| Subject: RATTLE NOISE FROM HEADER PANEL OF CONVERTIBLE TOP | Bulletin No: 09-045/15 |
| | Last Issued: 12/23/2015 |

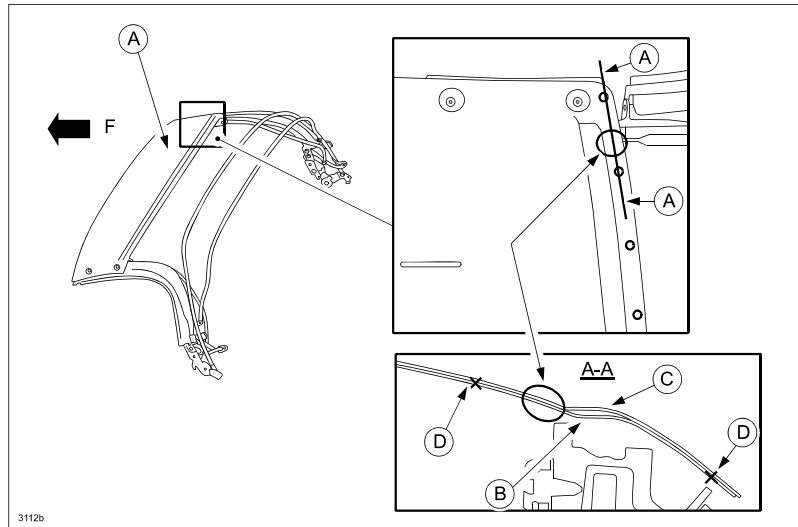
Some vehicles may exhibit a rattle noise (A) from the header panel (B) of the convertible top when driving on a rough road.

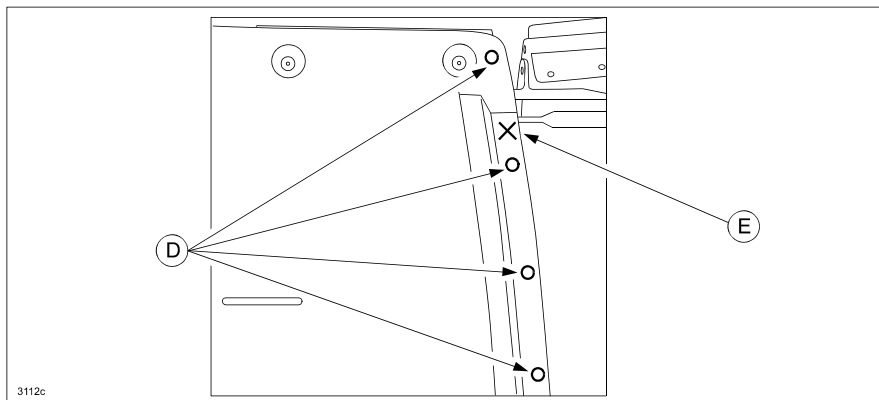
The header panel (A) is formed by two aluminum panels, inner (B) and outer (C). When receiving an input force by driving on a rough road, the two panels at the problem area, where spot welds are located (D), may warp and change relative position causing the rattling noise. (F=Front)

To correct the problem, a spot weld (E) has been added to the problem area, where the original spot welds are located (D), to increase the rigidity and prevent the warping.
